**Re: FortisBC Energy Inc. (FEI)**

**Application for a Certificate of Public Convenience and Necessity for the Inland Gas Upgrade Project (the Application)**

**Response to the Commercial Energy Consumers Association of British Columbia (CEC) Information Request (IR) No. 1**

**Figure 1: Coastal Dig Locations (2 active and 6 passive corrosion sites)**

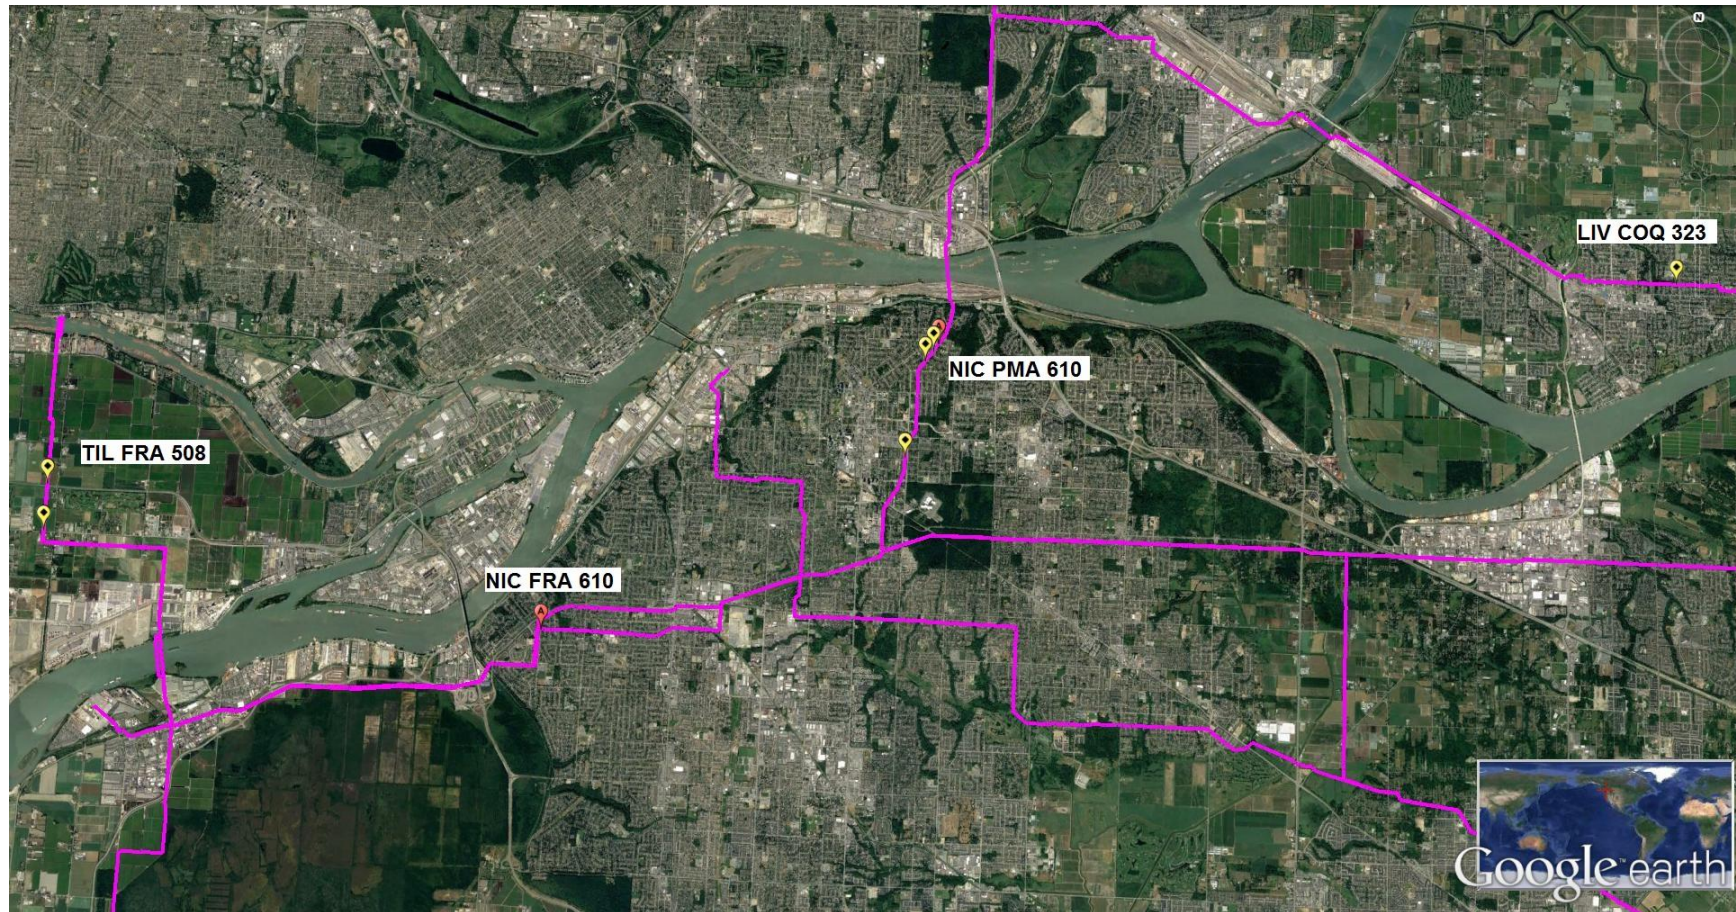
4            10.1    Please provide a map identifying the 90 integrity digs and the 72 instances of  
5                    active corrosion.

8     The 90 integrity digs locations are provided in three regional maps (Coastal, Interior and  
9     Vancouver Island) as shown below. Red balloon icons indicate active corrosion sites (72  
10    instances) and yellow balloon icons indicate passive corrosion sites (18 instances, 6 in Coastal  
11    and 12 in Interior as shown in Figure 2).
